CALIFORNIA PUBLIC UTILITIES COMMISSION  
Utilities Division

SAFETY REPORT  
ON  
LIQUEFIED PROPANE STORAGE  
WITH LOW TEMPERATURE PIPELINE  
OF  
PETROLANE INCORPORATED  
SAN PEDRO, CALIFORNIA

San Francisco, California  
September, 1977

FIGURE 1

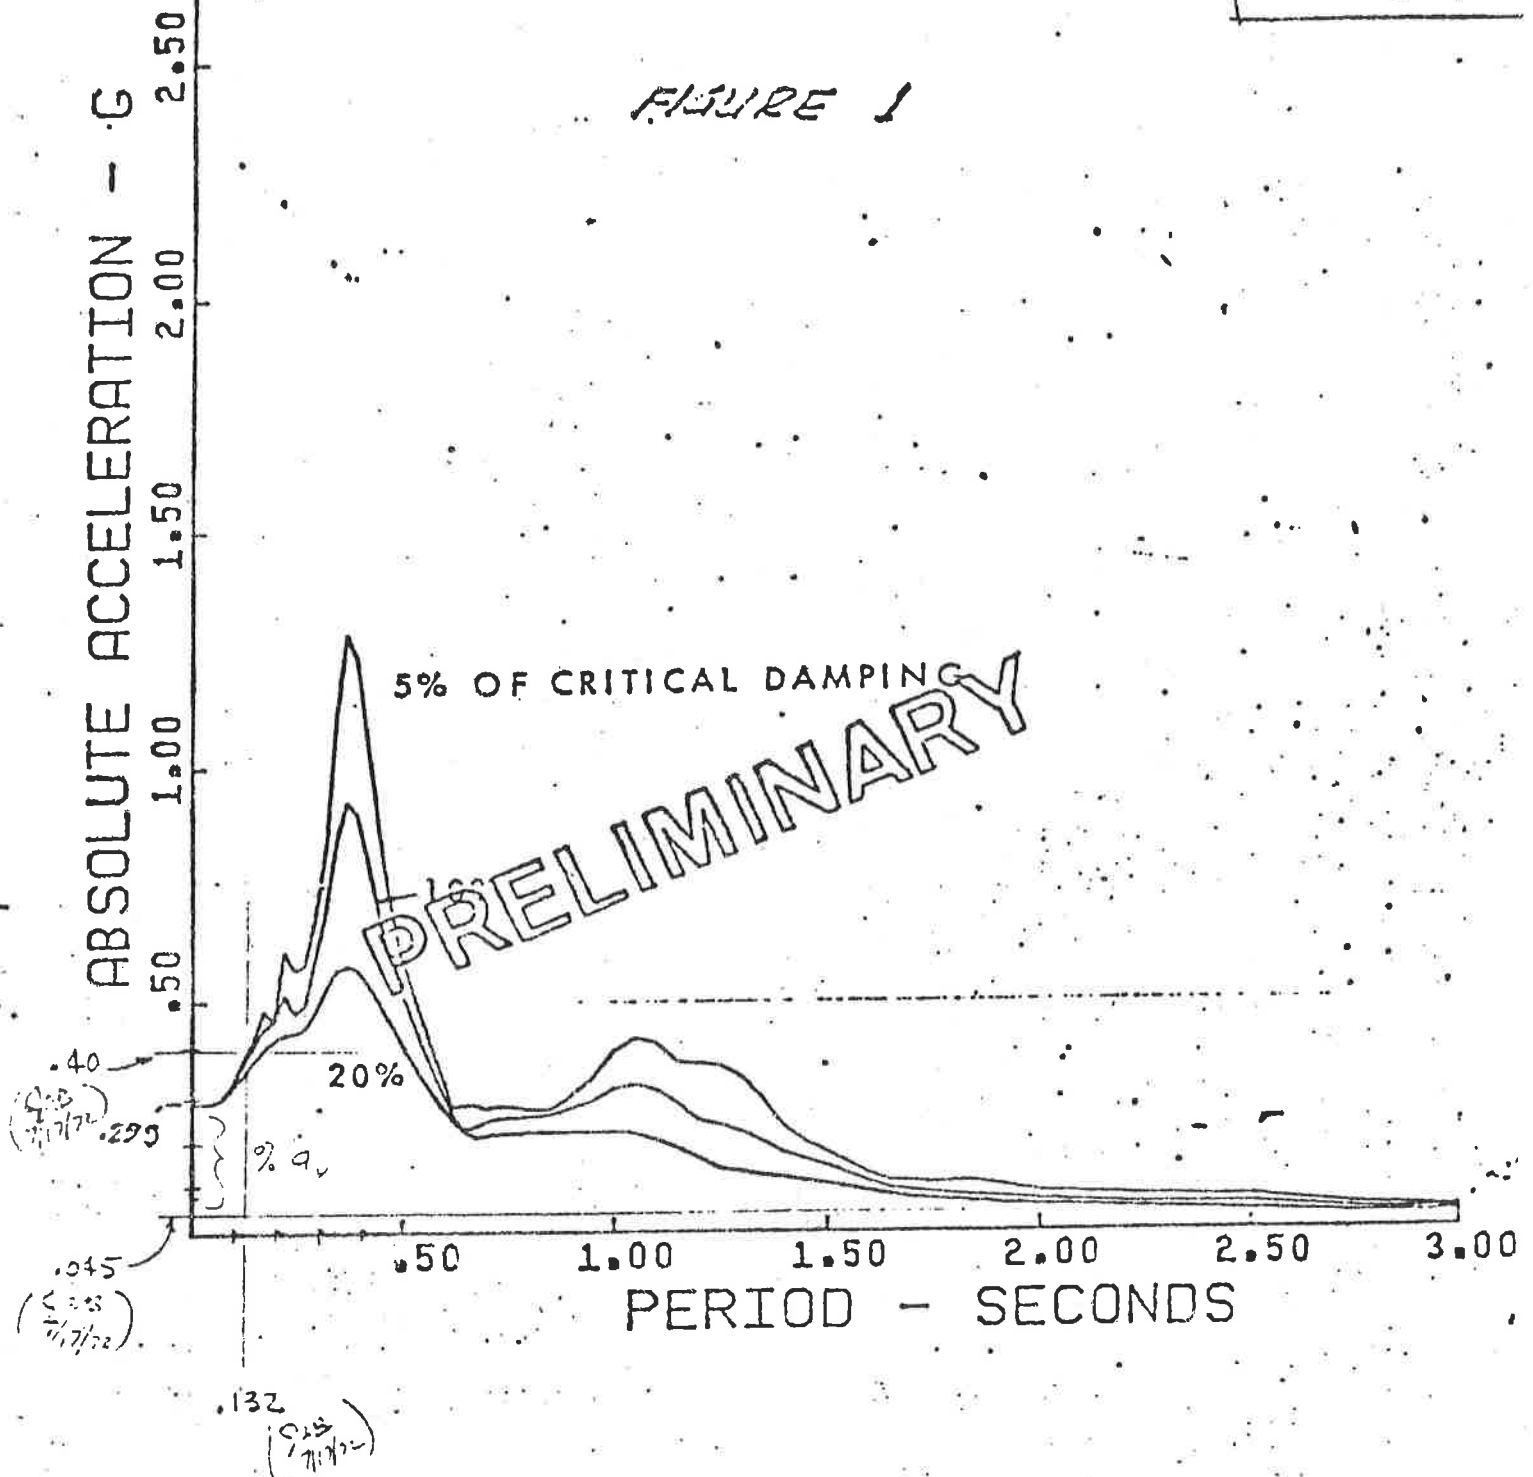
9. The response spectrum curve was developed by Converse Davis Dixon Associates.<sup>5/</sup> The zero period (or ground) acceleration for this curve is 0.29 g, and the acceleration at the period of the tanks (0.132 seconds) is 0.4 g.

26. The LPG storage tanks were designed to withstand a maximum acceleration of 0.4 g. (See CB&I explanation in paragraph 8.) Recent studies have indicated that the site might experience a bedrock acceleration in excess of 0.7 g within its lifetime. In their reanalysis, Converse Davis Dixon Associates developed Response Spectra Curves for earthquakes on the Palos Verdes Fault of magnitude 6.0, 6.5 and 7.2. From these curves, values for the peak ground acceleration (zero period) and the acceleration at the period of the tanks (0.132 seconds) can be determined. As can be seen for earthquake magnitudes of 6.5 and 7.2, the

The term  $\ddot{x}$  is defined as "maximum ground acceleration", and we interpreted this to be the acceleration associated with the impulsive liquid mass acting at the "tank" period. Technically speaking, the acceleration at 0 period (or ground acceleration) could have been used for this term. However, CBI policy has been to use the amplified acceleration (at the period of 0.132 seconds in our calculations on sheet 4 of 20). Recent findings (see reference 1) have confirmed that the amplified acceleration, rather than the ground acceleration, should be used in the analysis. This is where the slight discrepancy in the definition of terms arises.

In discussing this with Jim Bell of Converse Davis Dixon, we tentatively agreed that the calculations could be revised to define  $\ddot{x}$  as "maximum spectral acceleration", rather than "maximum ground acceleration". However, after further consideration, we believe the calculations should not be changed and that the explanation given in this letter should be attached to the calculations for permanent record to identify the assumptions made.
